State Significant Development Application (SSDA) Access Report

Norwest Data Centre Stage 2, 3 Brookhollow Avenue, Baulkham Hills NSW 2153

Prepared for: Green Square DC
Our Ref: 25000860 | Issue date: 03 December 2025

MBC Access Review Mark Ups

1	2	3	28/11/2025											Drawing By SP, BC	Drawing Title LEVEL 05 - FLOOR PLAN

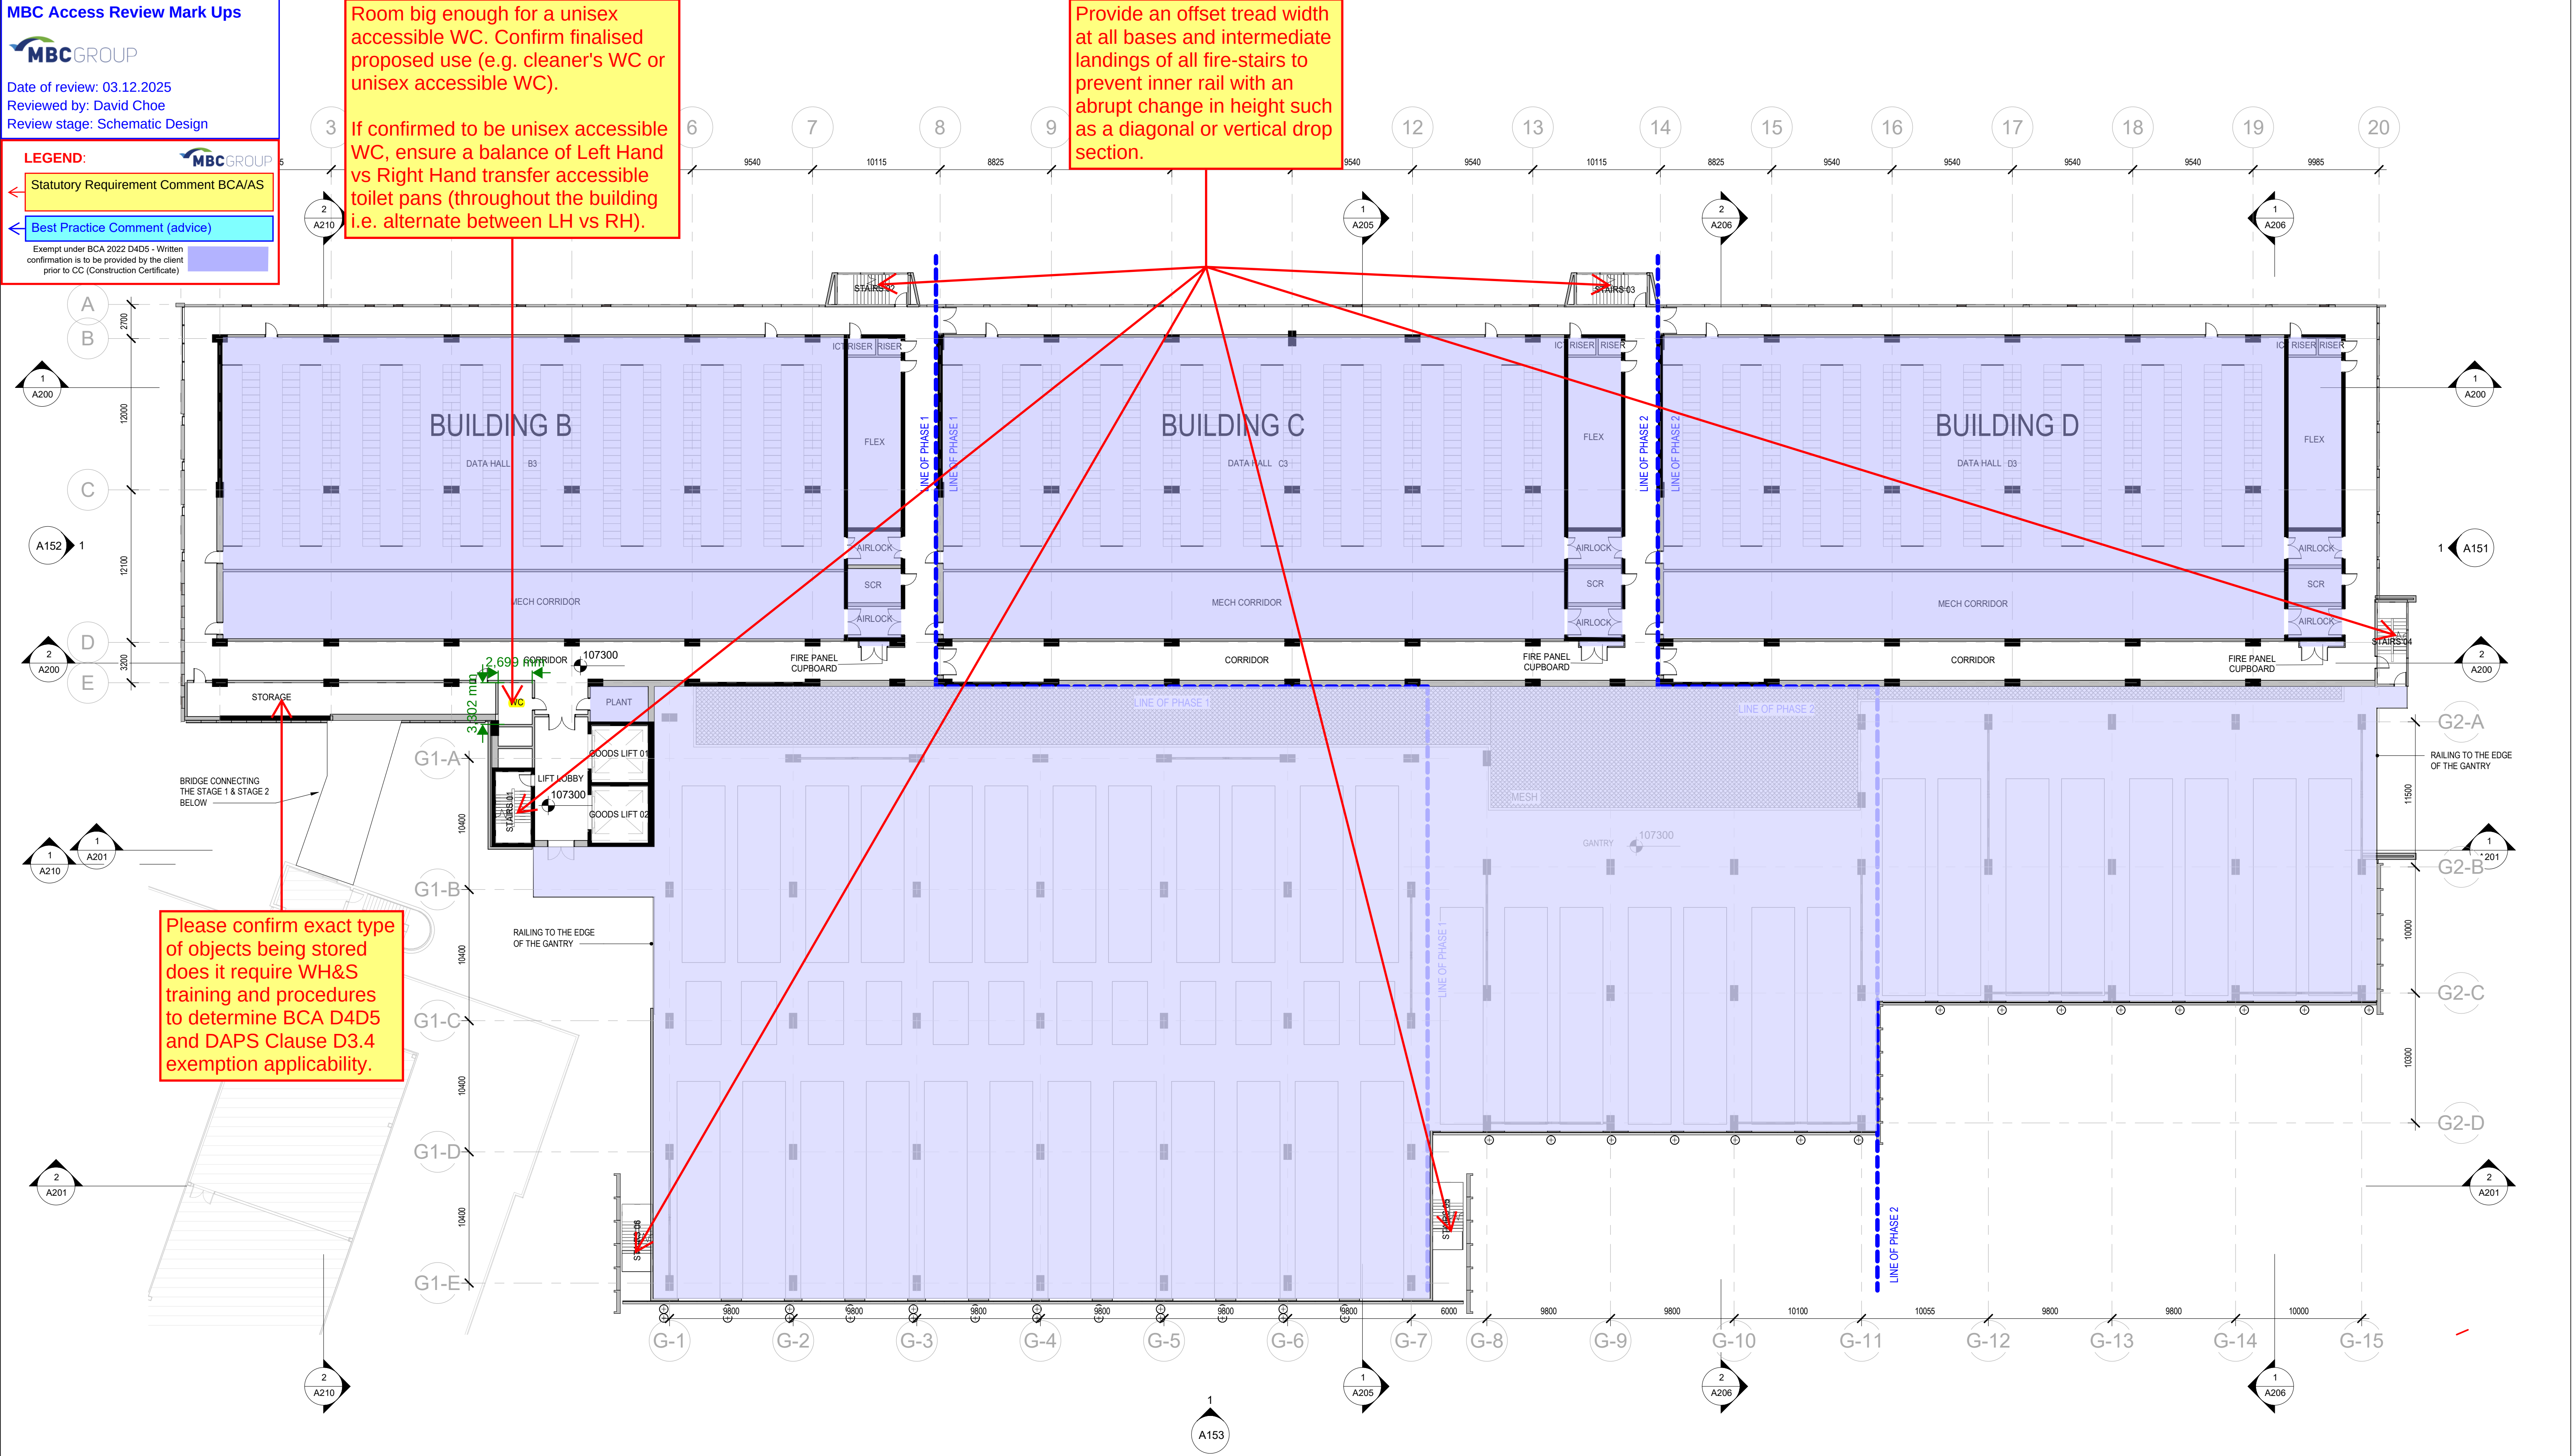
Exempt under BCA 2022 D4D5 - Written confirmation is to be provided by the client prior to CC (Construction Certificate)

Room big enough for a unisex accessible WC. Confirm finalised proposed use (e.g. cleaner's WC or unisex accessible WC).

If confirmed to be unisex accessible WC, ensure a balance of Left Hand vs Right Hand transfer accessible toilet pans (throughout the building i.e. alternate between LH vs RH).

Provide an offset tread width at all bases and intermediate landings of all fire-stairs to prevent inner rail with an abrupt change in height such as a diagonal or vertical drop section.

Please confirm exact type of objects being stored does it require WH&S training and procedures to determine BCA D4D5 and DAPS Clause D3.4 exemption applicability.

Noted.

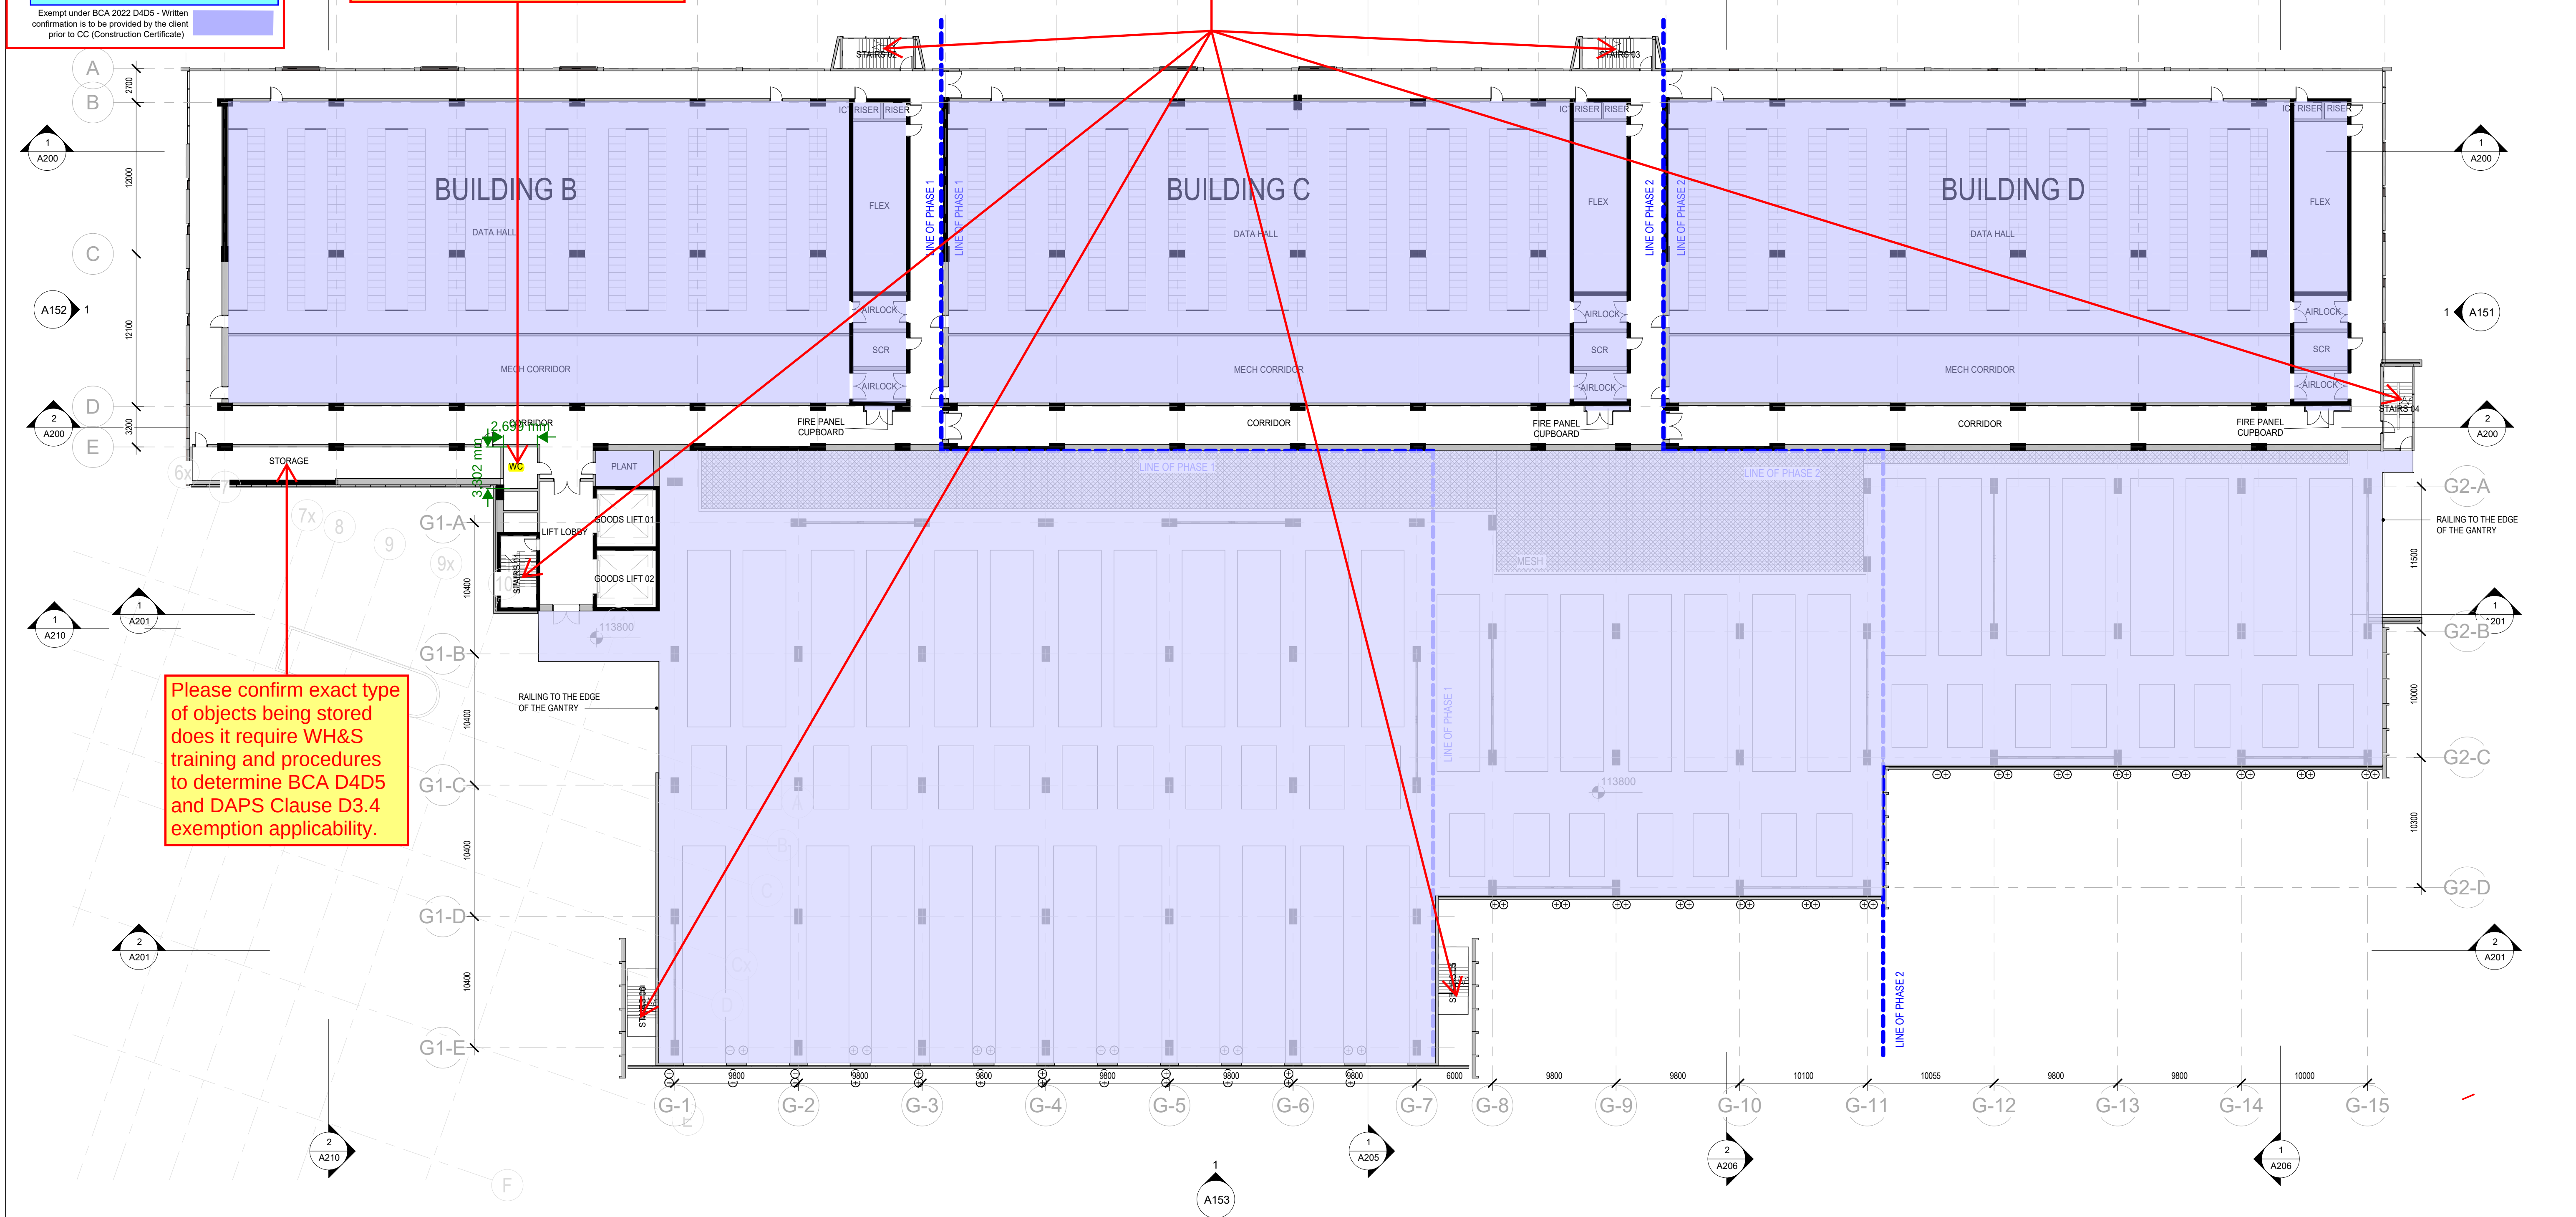
Room big enough for a unisex accessible WC. Confirm finalised proposed use (e.g. cleaner's WC or unisex accessible WC).

If confirmed to be unisex accessible WC, ensure a balance of Left Hand vs Right Hand transfer accessible toilet pans (throughout the building i.e. alternate between LH vs RH).

Provide an offset tread width at all bases and intermediate landings of all fire-stairs to prevent inner rail with an abrupt change in height such as a diagonal or vertical drop section.

Noted.
